# Access Compliance Report

## Public Rights-of-Way

Intersection ID: 5104	Main Street: E_MALLARD_CREEK_CHURCH_RD	Cross Street: MARY_ALEXANDER_RD	Location: W
ADA ID: A6CA5C623056	Ramp Type: Perp	Initial Pass/Fail: Fail	Overall Compliance: No
Severity Score: 13.75			
Codes/Mitigation Info/Possible Solution		Field Measurements/Component Compliance

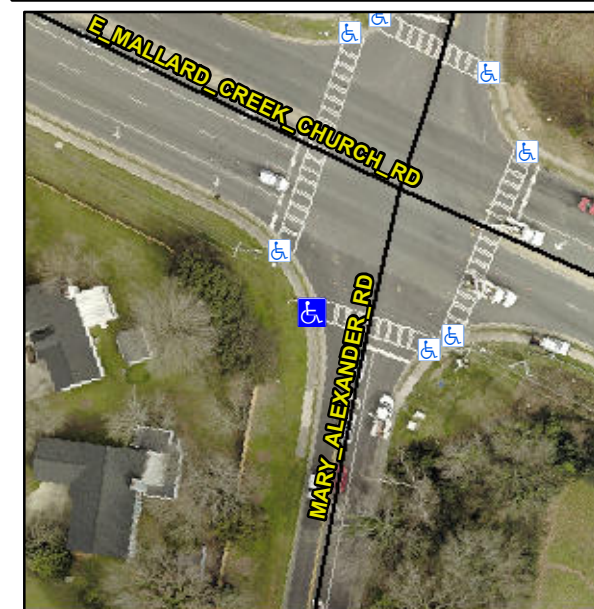
**R304.2.2**

Compliance	Description	Data	Compliance	Description	Data
N/A	Ramp Length (in)	70.0	No	Ramp Slope (%)	10.0
Yes	Ramp Width (in)	48.0	Yes	Ramp XSlope (%)	4.5
N/A	Flare Type LT	N/A	N/A	Flare Type RT	N/A
N/A	Flare Slope LT (%)	N/A	N/A	Flare Slope RT (%)	N/A
N/A	Flare Traversable LT?	N/A	N/A	Flare Traversable RT?	N/A
N/A	Landing Length (in)	N/A	N/A	DWS Provided?	N/A
N/A	Landing Width (in)	N/A	N/A	DWS Contrast?	N/A
N/A	Landing Slope (%)	N/A	N/A	DWS Length (in)	N/A
N/A	Landing X Slope (%)	N/A	N/A	DWS Full Width?	N/A
N/A	Landing Curb? (Y/N)	N/A	N/A	DWS Offset (in)	N/A
N/A	Shared Landing?	N/A			
N/A	Gutter Ponding?	N/A	N/A	Gutter Slope (%)	N/A
N/A	Gutter Lip Ht (in)	N/A	N/A	Gutter X Slope (%)	N/A
N/A	Painted X Walk1?	Yes	N/A	Painted X Walk2?	N/A
	X Walk 1 Direction	To SE		X Walk 2 Direction	N/A
N/A	X Walk 1 Width (in)	99.0	N/A	X Walk 2 Width (in)	N/A
	X Walk 1 Slope (%)	5.3		X Walk 2 Slope (%)	N/A
	X Walk 1 X Slope (%)	8.5		X Walk 2 X Slope (%)	N/A

**Remove & Replace Entire Ramp.**
